Your Ref
AL/34/17/HH

Our Ref
PLAN-018050

Proposal: Single storey extension, car port & new first floor window.
Site: The Studio, Tudor Drive, Westergate, Aldingbourne PO20 3YT.
AL/34/17/HH

Southern Water MapGuide Browser

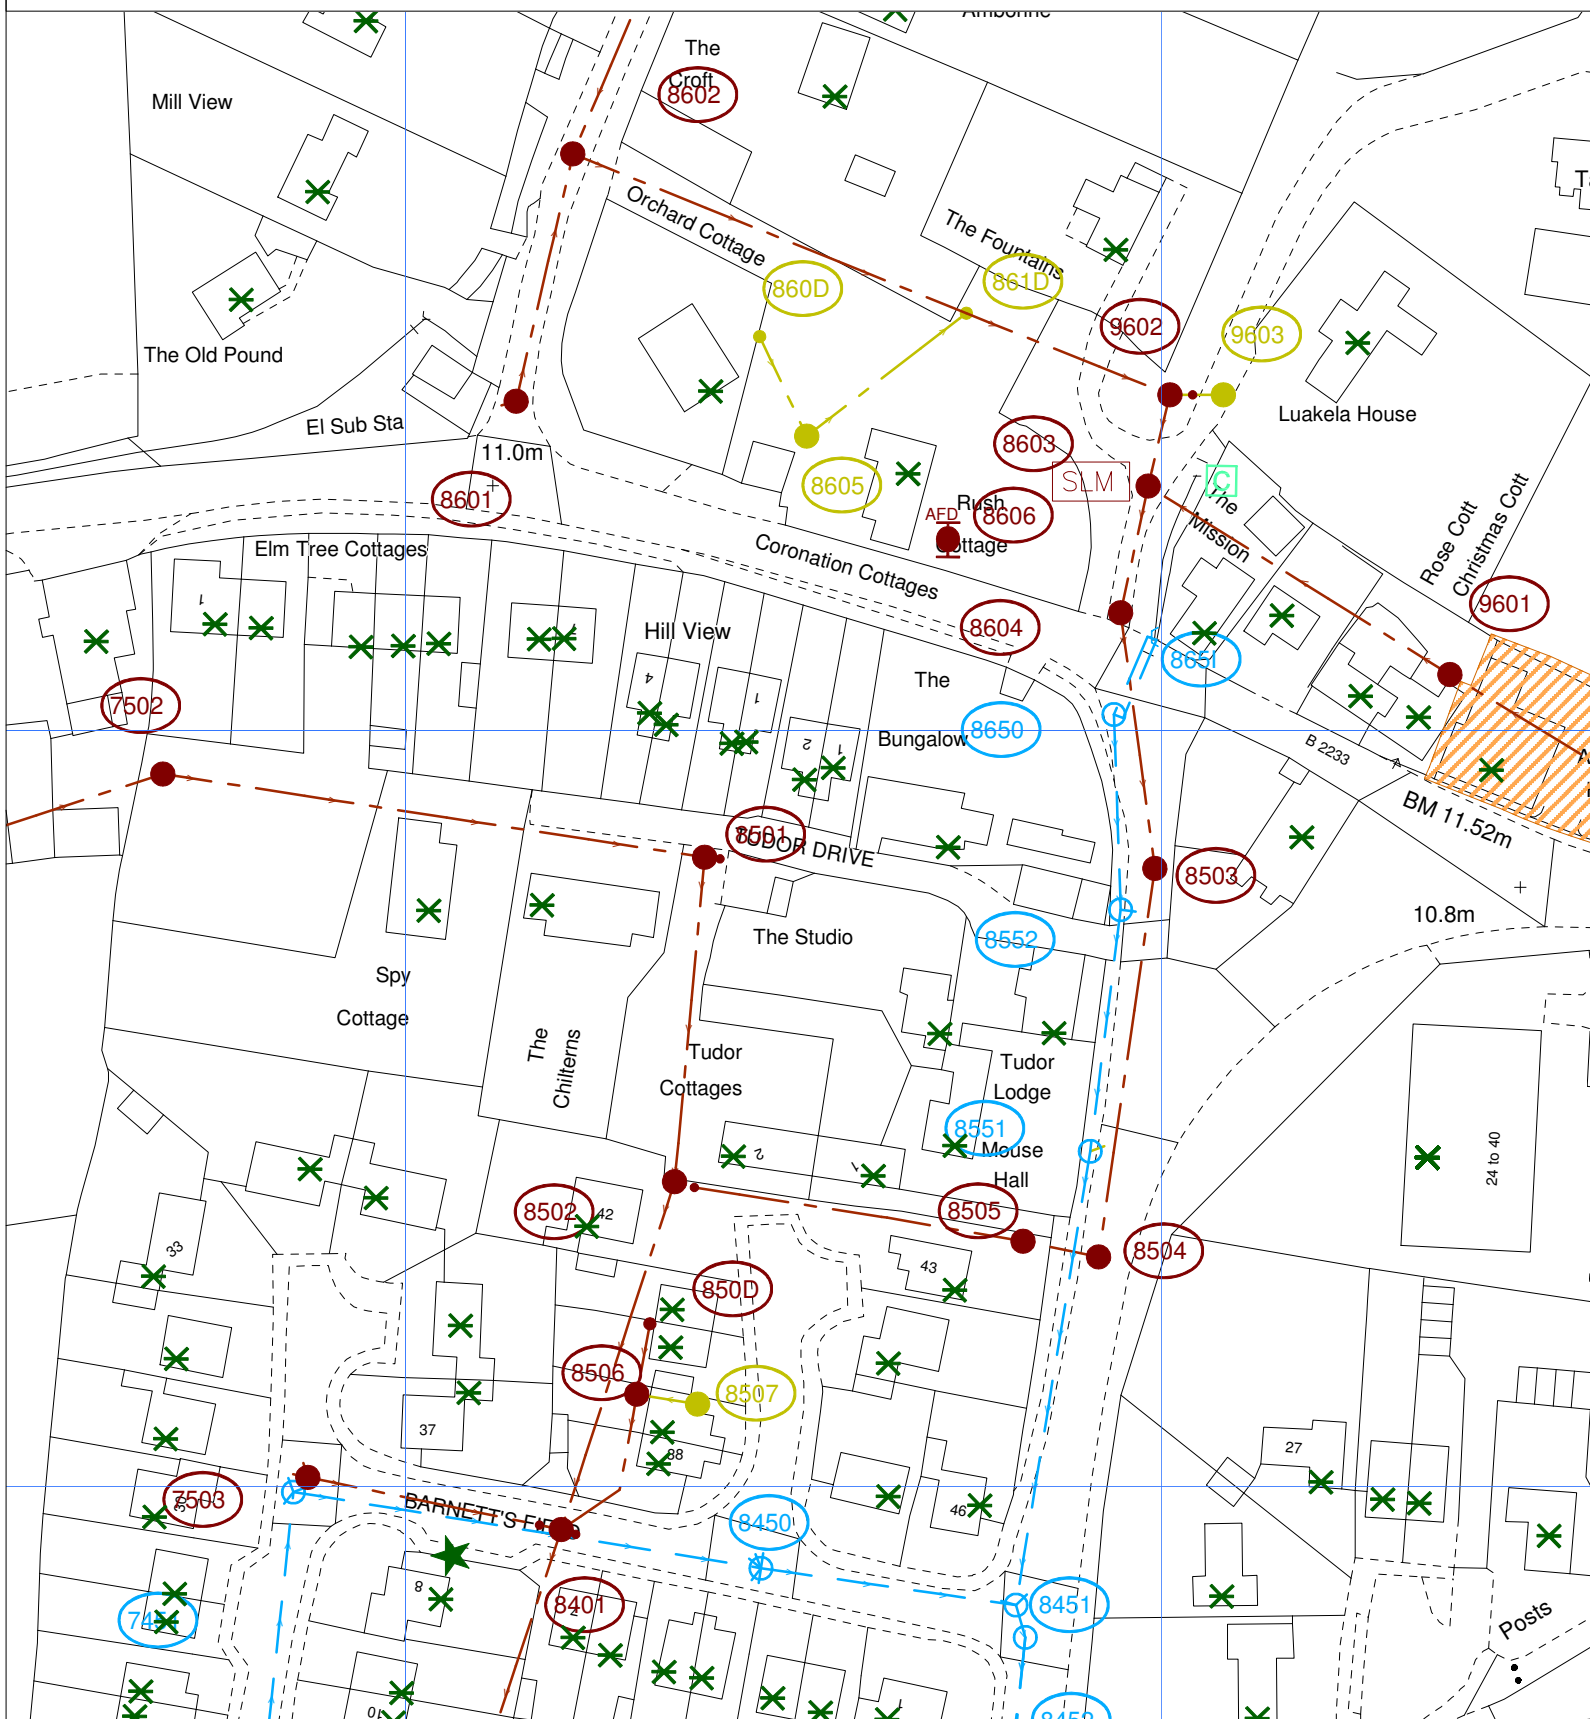
The positions of pipes shown on this plan are believed to be correct, but Southern Water Services Ltd accept no responsibility in the event of inaccuracy. The actual positions should be determined on site.
